MICRo CONTROLLER

TITLE: Sheet_1		REV: 1.0
嘉立创EDA	Company: Your Company	Sheet: 1/1
	Date: 2022-12-06 Drawn By: Mimosa

NEOPIXL

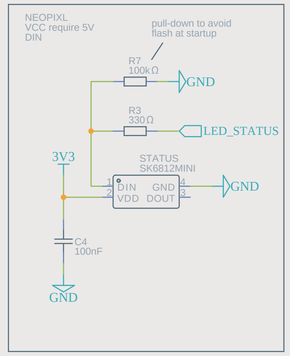
V2.0:
POT CONTROL: IO34
Inductance change for a 2A one
The 5V supply for the LED is now before the inductance
since the inducated is limited to 2A but the mosfet can deliver 4A
now the LED supply can received 4A
Added a TVS on the main power line
Added a TVS on the LED data line
change the onboard LED for a NeoPixel
